RE: NOV #85-4-15-1, Abatement Response Plans received on September 20, 1985, Soldier Creek Coal Company, Soldier Canyon Mine, ACT/007/018

Soldier Creek submitted abatement plans in response to a violation concerning failure to construct sediment pond according to approved mine plans. These abatement plans modify the existing plan by placing additional riprap material on the toe of the outslope of the sediment pond and in the perennial stream channel.

PROJECT NAME SOLDIER CREEK SEDIMENT POND - R. HARDEN

100--

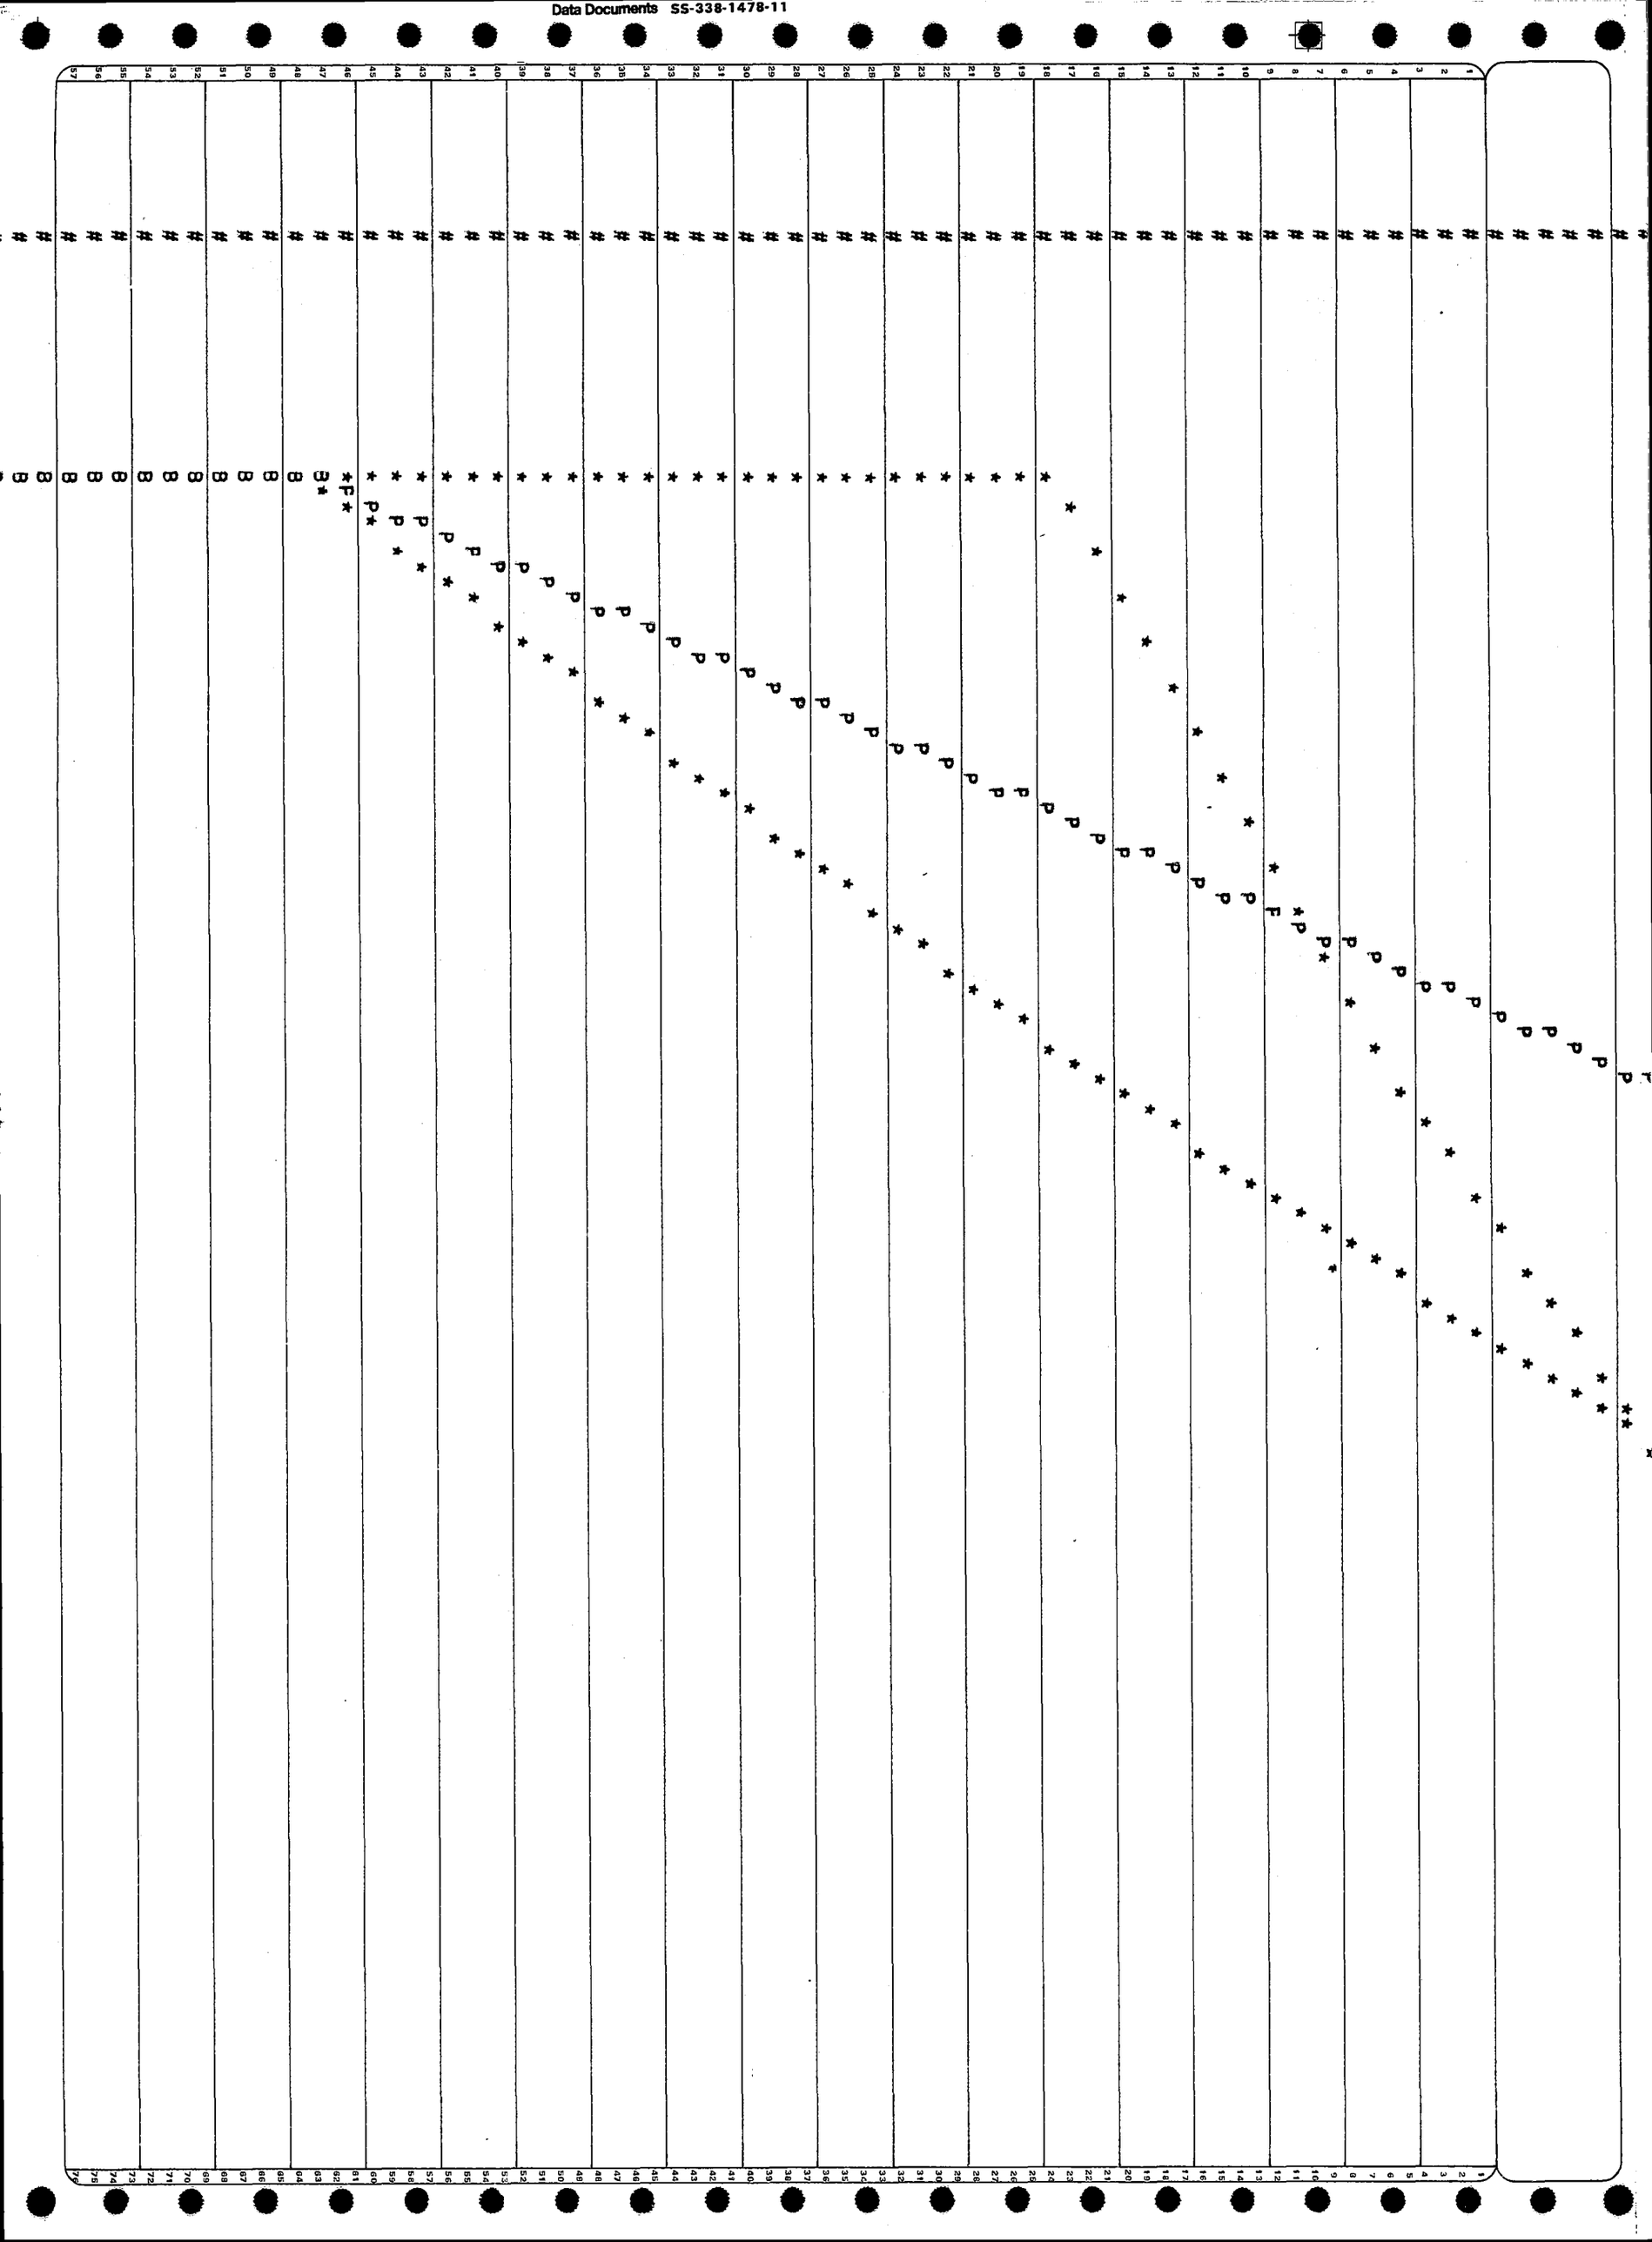
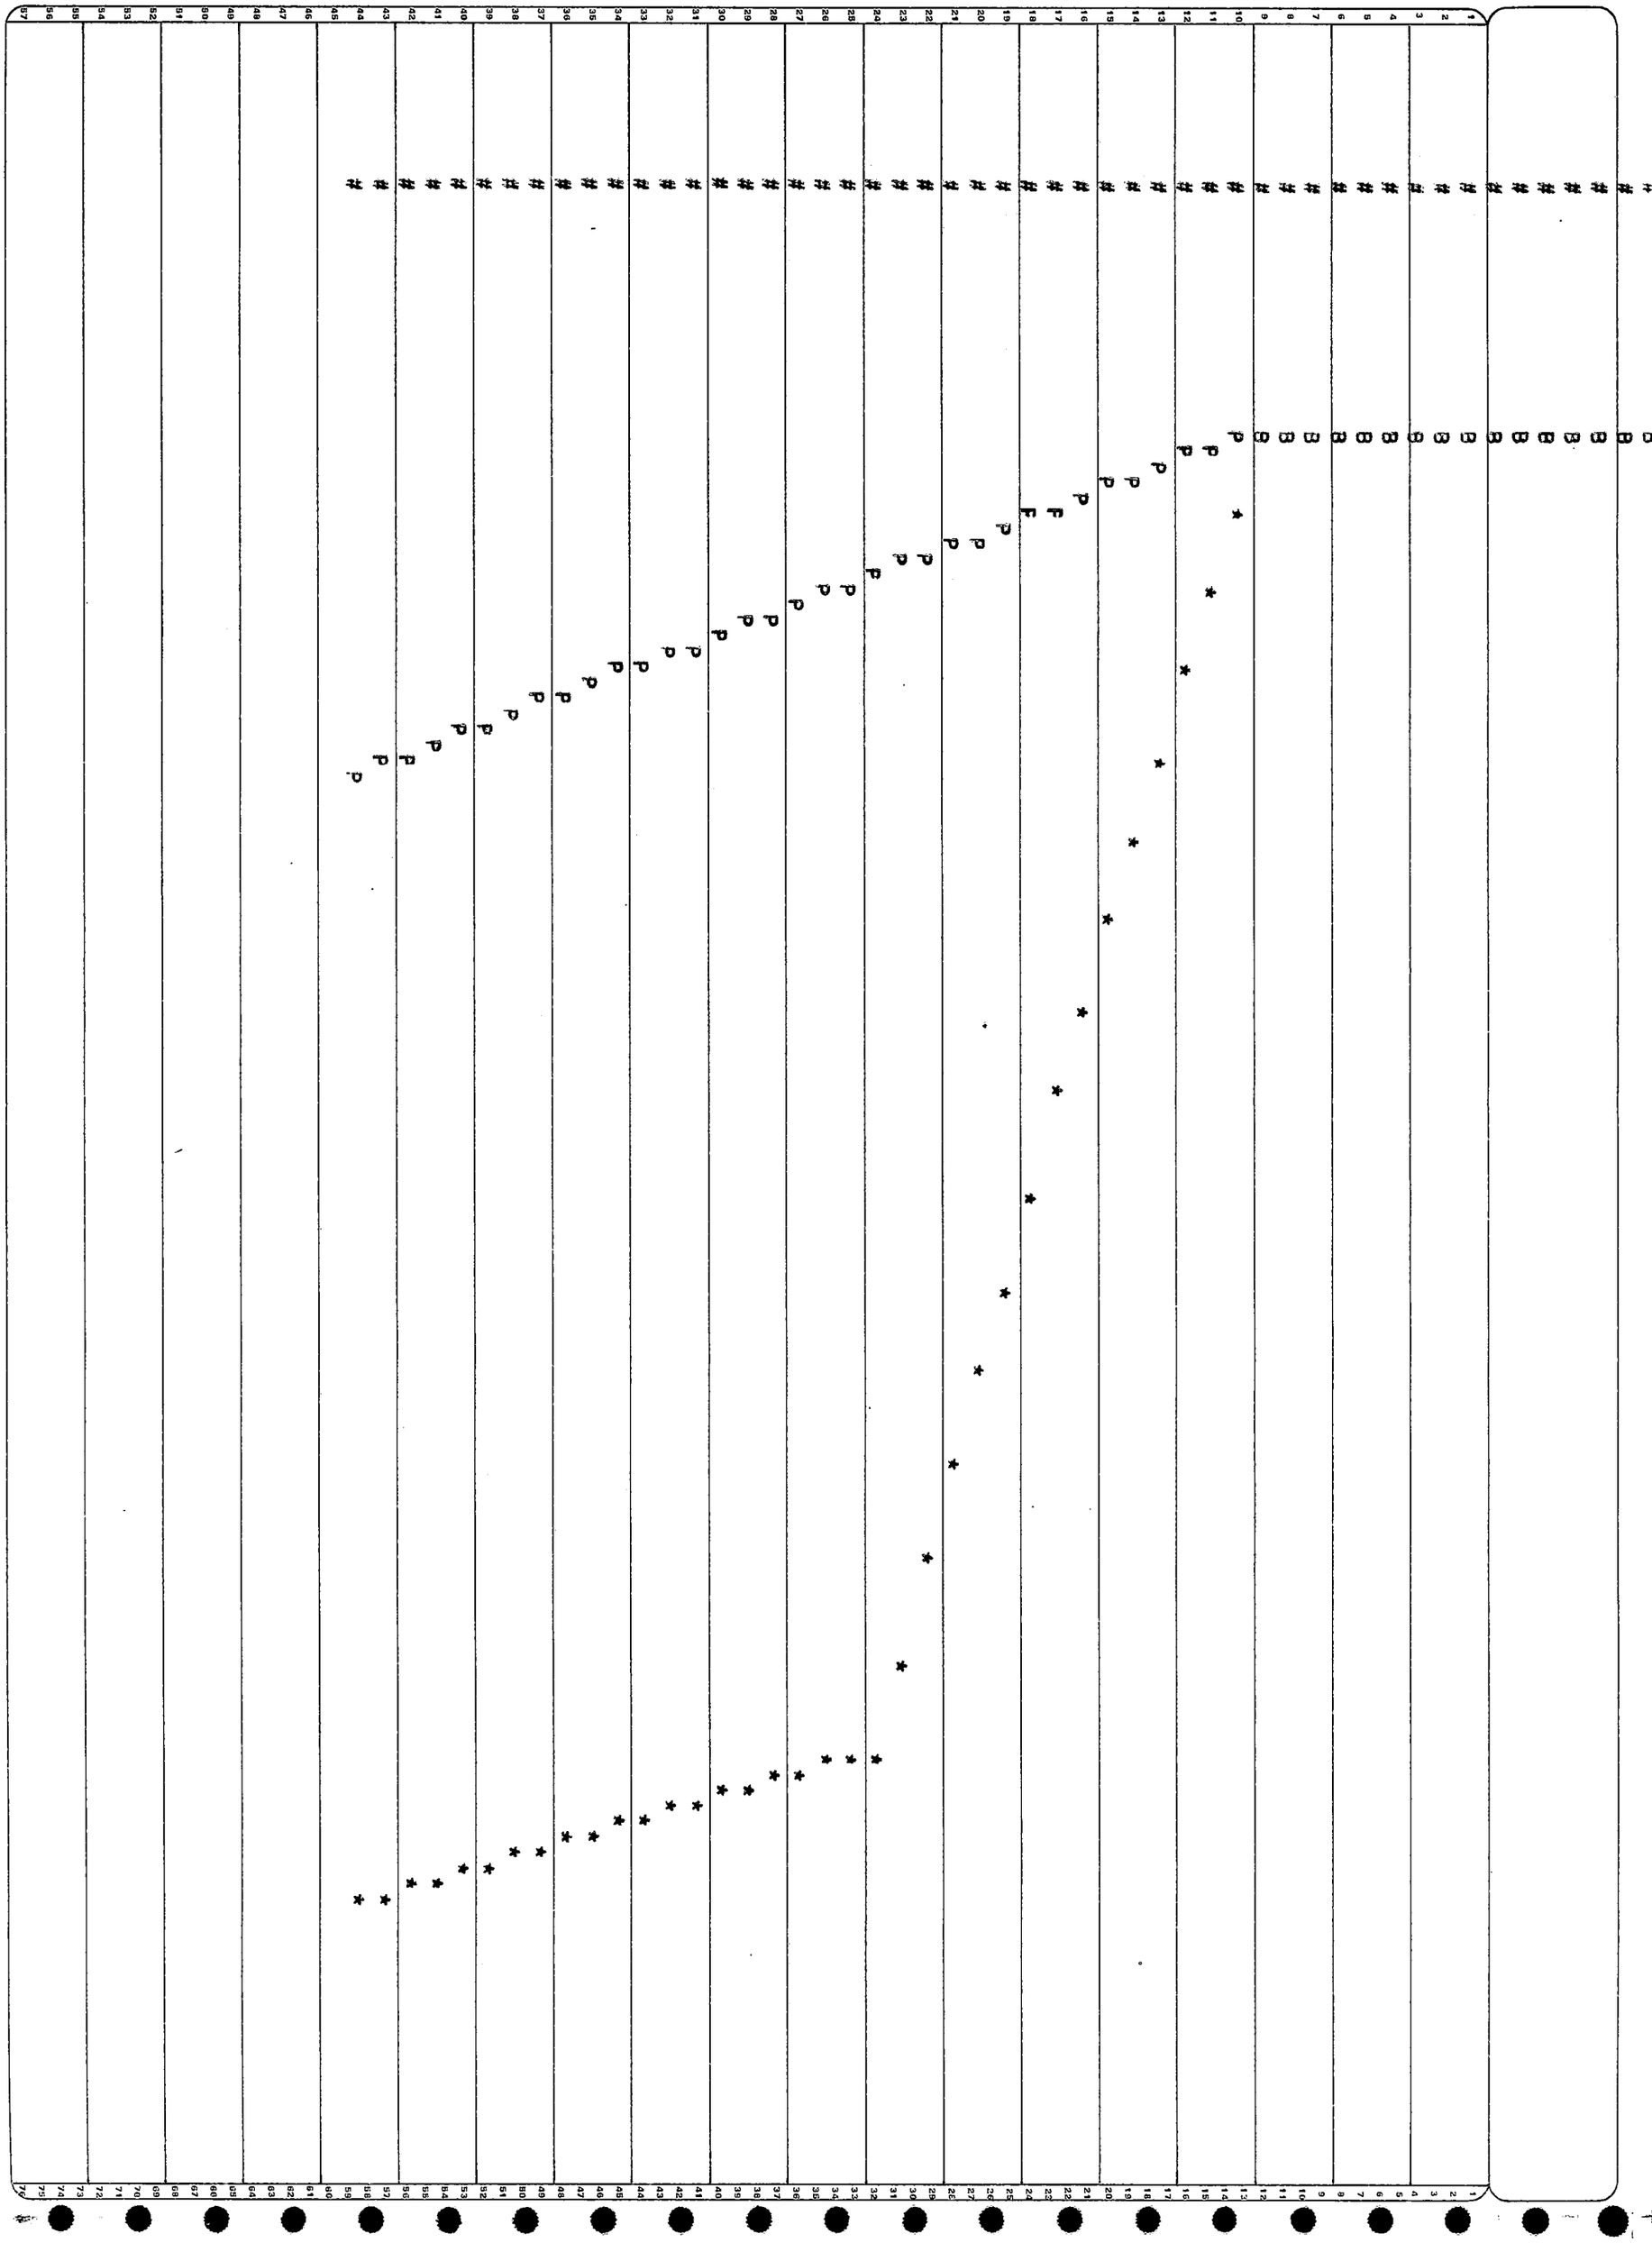
3. Calculations for the stability of the sediment pond are not sufficient to show stability. Calculations by the Division indicate that the proposed has a factor of safety which is considerably less than 1.5. Design of embankments, including the opposite stream channel, must be revised and complete stability analysis of the embankments must be provided to ensure stability of 1.5 static.

Calculations regarding the stability of the sediment pond and stream channel embankments are as attached to this memo(computer printouts).
